OPERATIONAL WORKS LANDSCAPE

PROJECT: PROPOSED NEW DEVELOPMENT

AT: LOT 117 EATRIDGE STREET, VANTAGE, YATALA, QLD

Application No. OPW/2025/175

FENCING PLAN

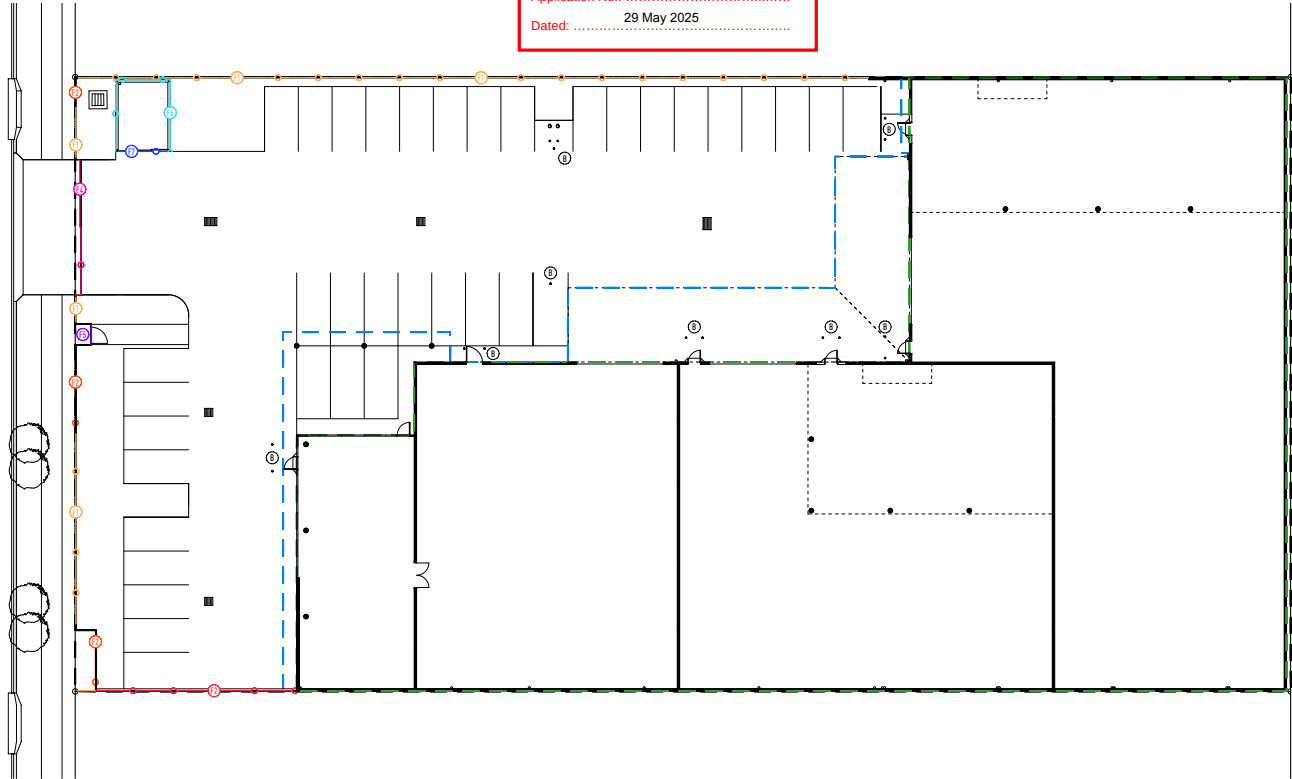
Note:
Any installed frontage fencing for the development must be at least 50% transparent

PLANTING PLAN

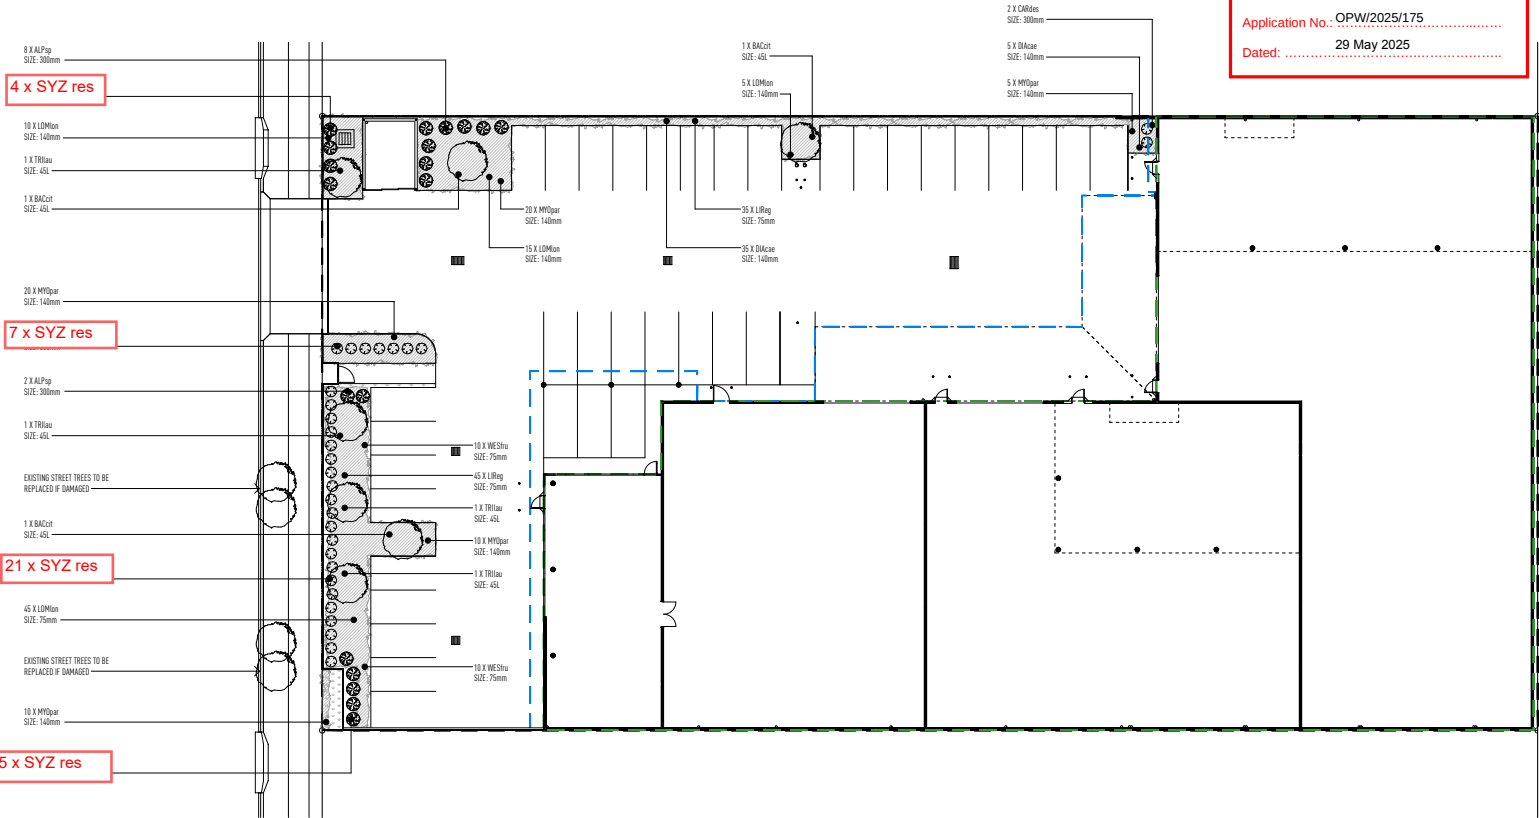
NOTE:
Plant quantities will need to be updated. Refer mark ups on landscape plans for revised plant quantities.
